☒ Oil Well ☐ Gas Well ☐ Other8. Well Name and No.  
CORRAL FLY 35-26 FEDERAL COM 22H

OXY USA Inc. respectfully requests to amend the APD for the following wells. The five wells will have a similar design. The specific details (i.e. depths, cement volumes, etc) attached are for the 22H.

1. Amend the surface, intermediate, and production casings size, type, and depth, see attached DISTRICT II-ARTESIA O.C.D.

**OXY USA Inc. - Corral Fly 35-26 Federal Com #22H, 23H, 24H, 25H, 26H –  
Amended Drilling Plan**

**4. Pressure Control Equipment**

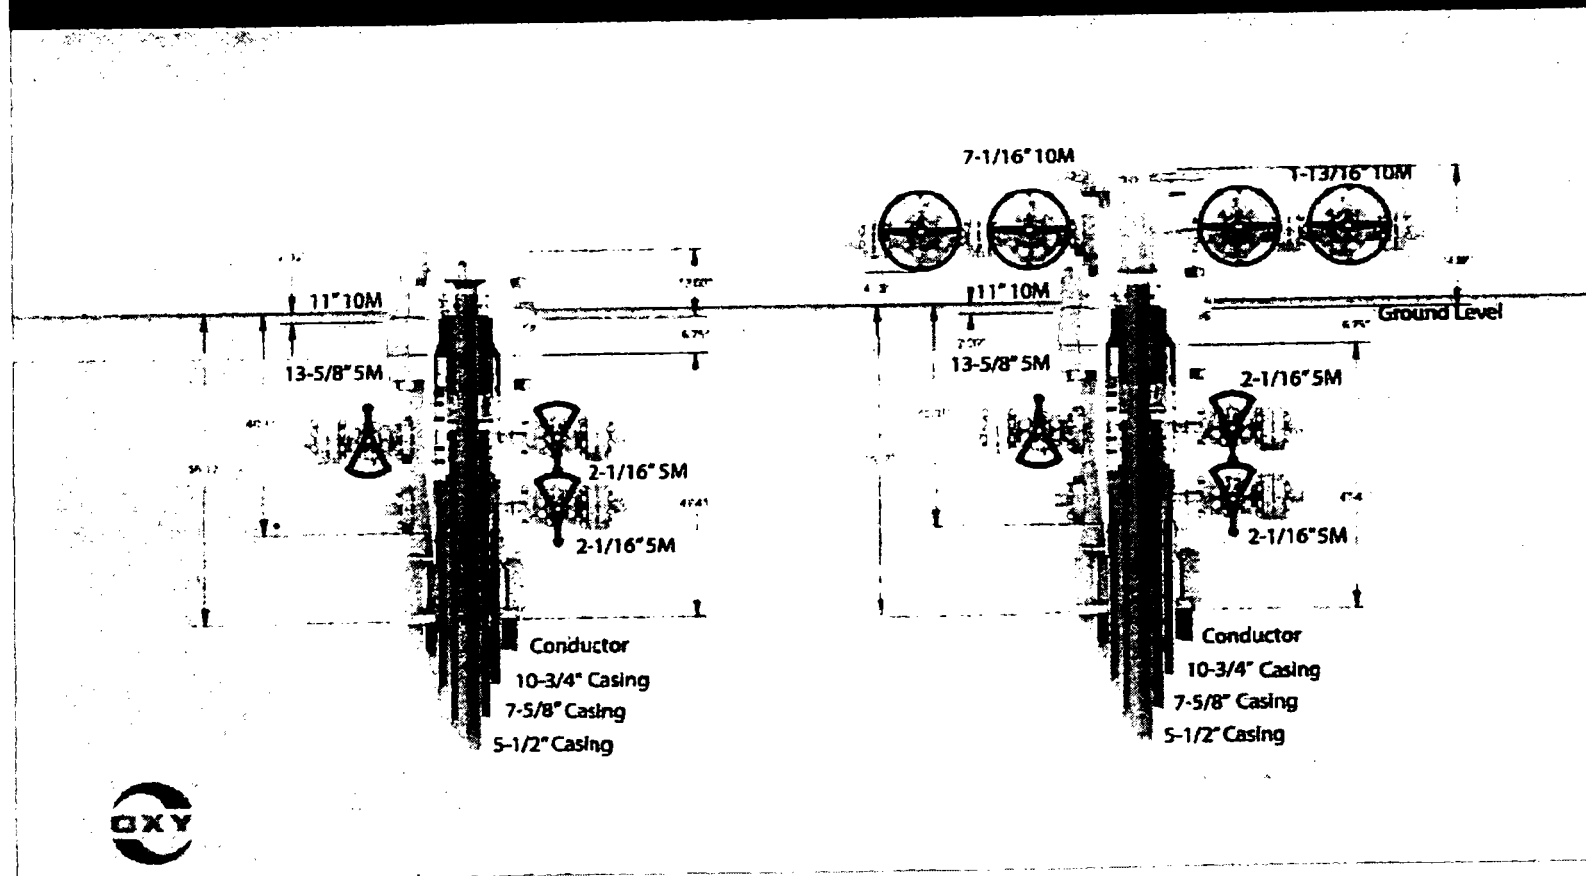
2. Amend the surface, intermediate and production casing cementing program, see attached.
3. Amend the pressure control equipment due to casing size changes, see attached.
4. Amend the mud program, depth and type, see attached.

BOP/BOPE will be tested by an independent service company to 250 psi low and the high pressure indicated above per Onshore Order 2 requirements. The System may be upgraded to a higher pressure but still tested to the working pressure listed in the table above. If the system is upgraded all the components installed will be functional and tested.
